# 1984 - 1985 Corvette: Service Bulletin: Noise in Direct Drive 4-Speed Manual Transmission

**Model and Year:** 1984 - 1985 Corvette

**Bulletin No:** 85-111

**Figure 1**

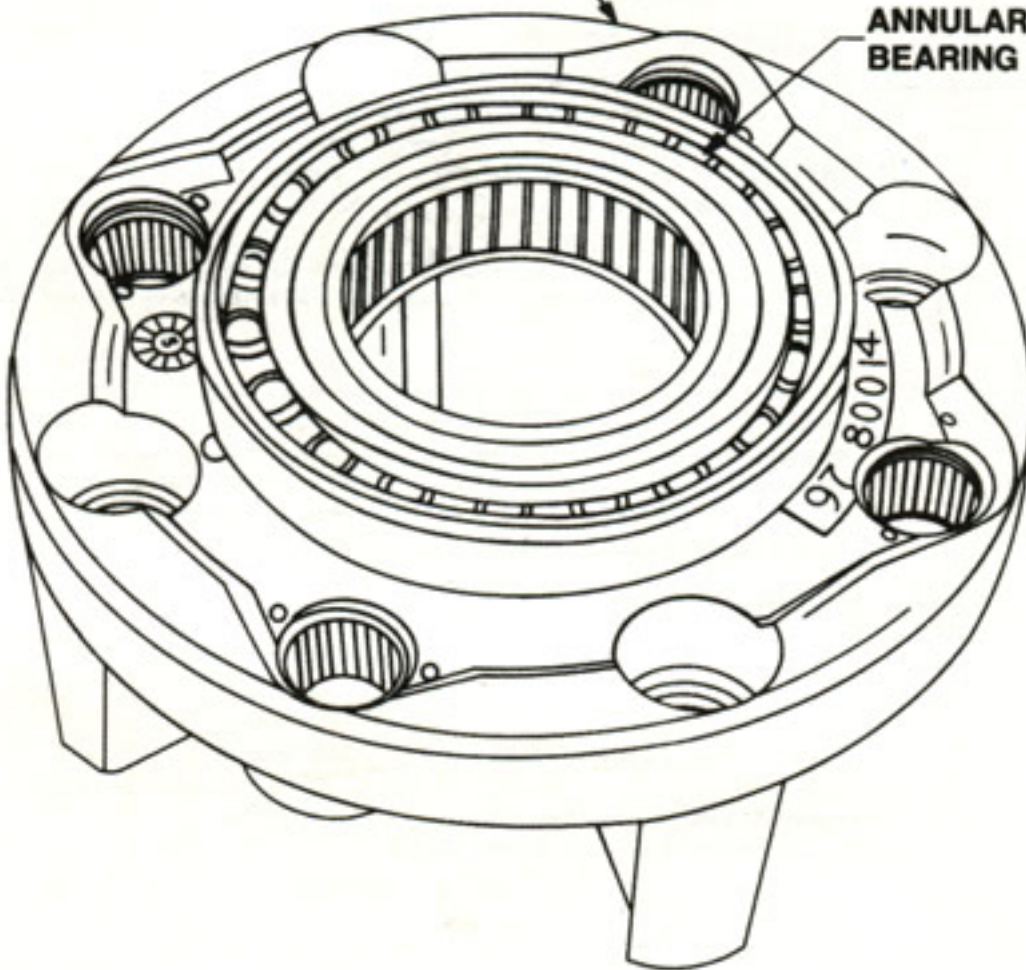
This condition may be caused by a worn annular bearing on the planetary gear carrier (see illustration). Continued operation of a noisy transmission in the direct drive model will cause damage to the planetary carrier, adapter plate, input sun gear, and input sun gear oil seal. If the input sun gear oil seal is damaged, it is possible for overdrive unit oil (Dexron II) to leak into the manual portion of the transmission.

On transmissions beginning with serial number D5C 14413 CF, a new planetary gear carrier has been released. This carrier (P/N 14094571) incorporates an annular bearing with increased thrust capacity.

1. Inspect the adapter plate surface, input sun gear, and input sun gear oil seal for damage. If there is indication of damage, the adapter plate, input sun gear, and input sun gear oil seal should be replaced. If there is no sign of damage, these parts may be reused.
2. If debris is present in the overdrive unit, completely disassemble and clean the unit, including the valve body. Thoroughly flush the cooler lines to remove any debris following the procedure outlined in the Vehicle Service Manual. Replace the oil filter.
3. If there is evidence of oil intrusion from the automatic overdrive unit into the 4-speed manual unit, the manual unit should be drained and flushed also.
4. Replace the planetary gear carrier with the new, P/N 14094571, carrier.
